BUILDING DEPARTMENT PERMIT

This is to certify that 468 Fore Street Realty, LLChas permission to Addition to Portland Harbor Hotel & interiorating existing day to Hotel Shell OnlyAT 468 FORE ST

Job Name: Portland Harbor Hotel Addition

Comments by Mike Nugent, Consulting Plans Examiner, City of Portland

STEEL ALTERNATING TREAD
STAIR BY LAFAYETTE INC. (OR
EQUAL)

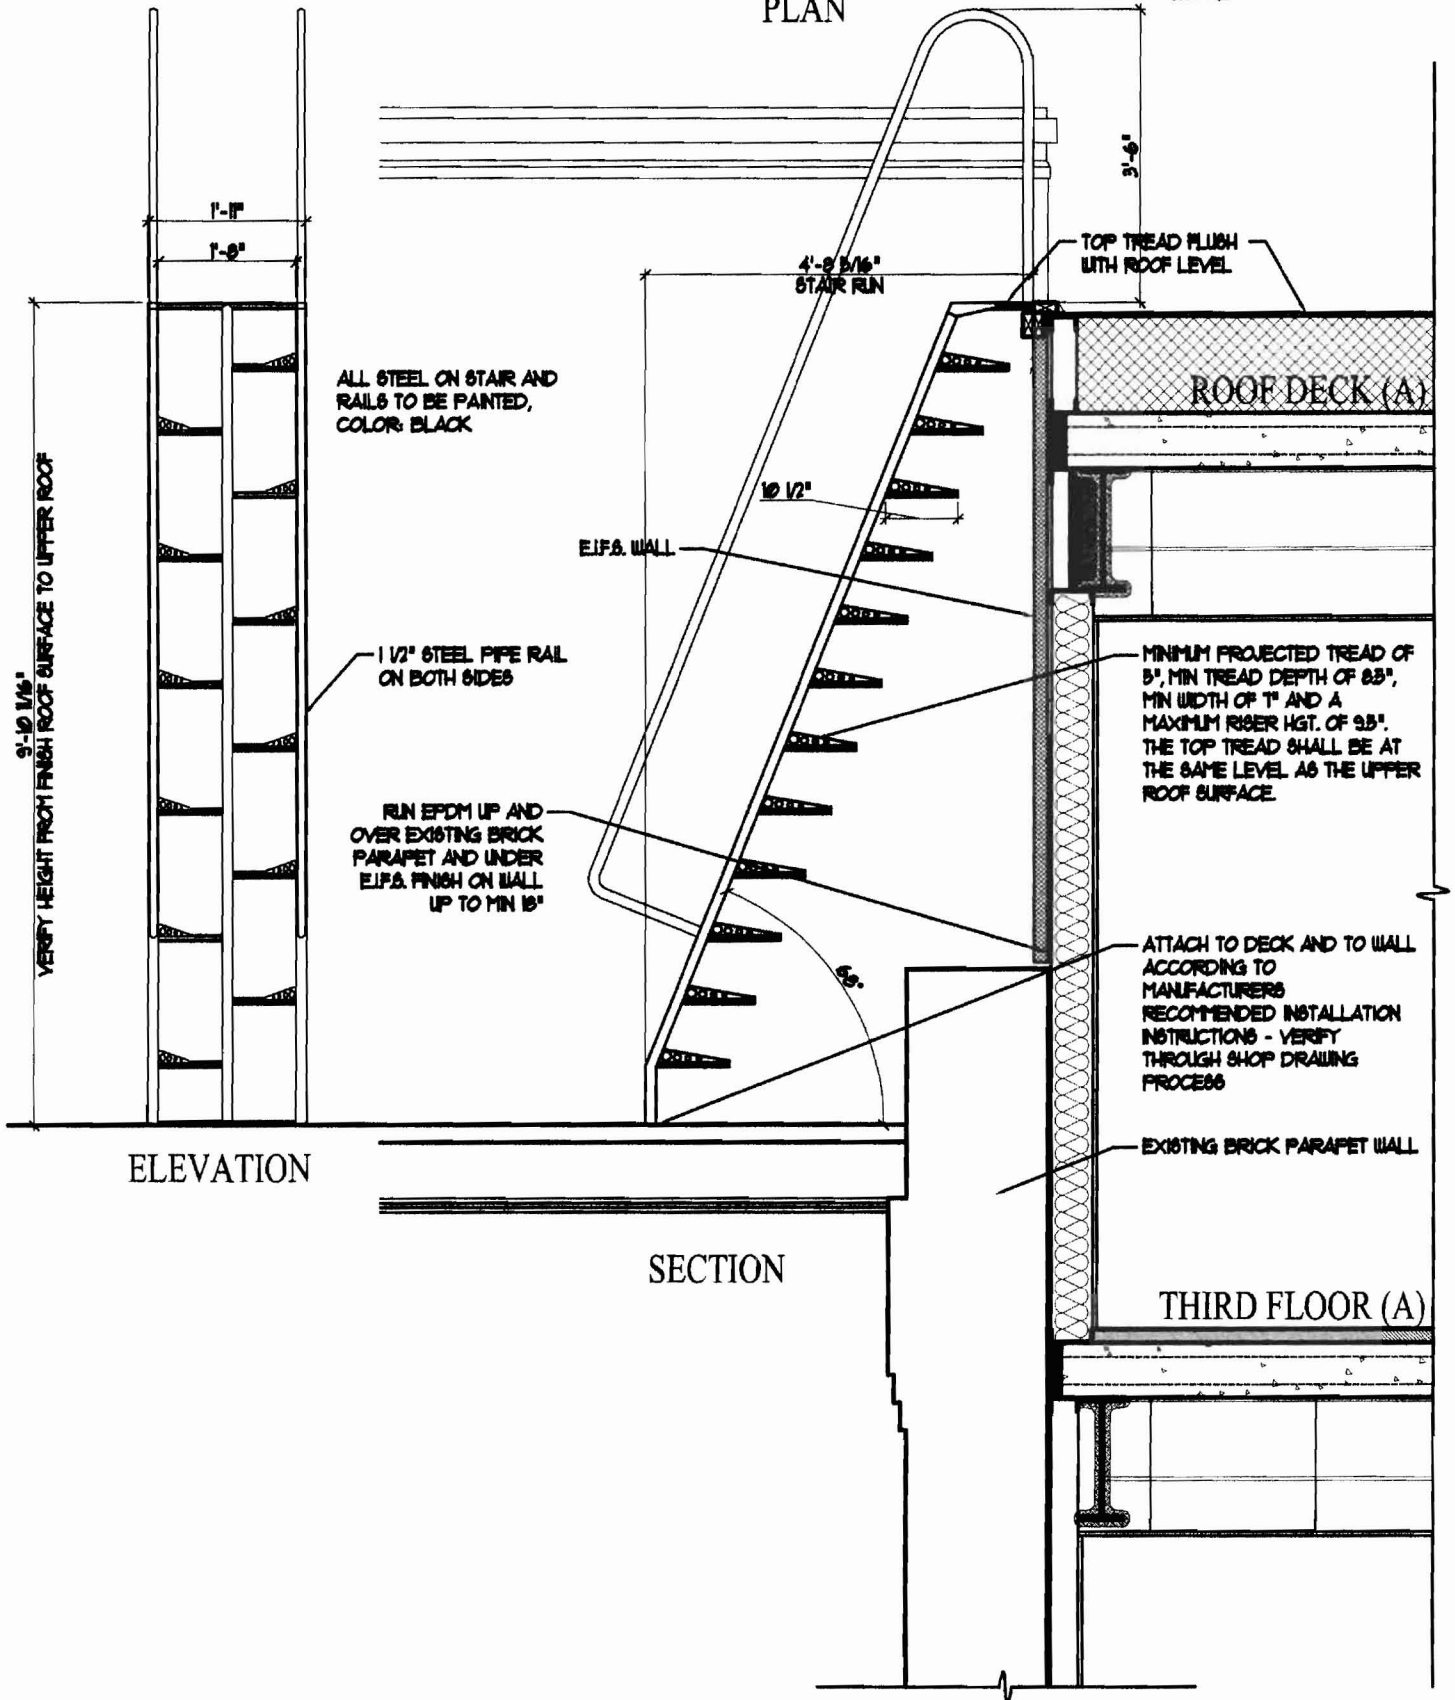
- 7) Please provide a UPC compliance assessment for the number of plumbing fixtures. Response: See response to item 6 above.
- 8) Please provide specs for the alternating tread stair that establishes compliance with Section 1009.10. Response: See attached drawing. This drawing and notation will be incorporated into the construction documents.
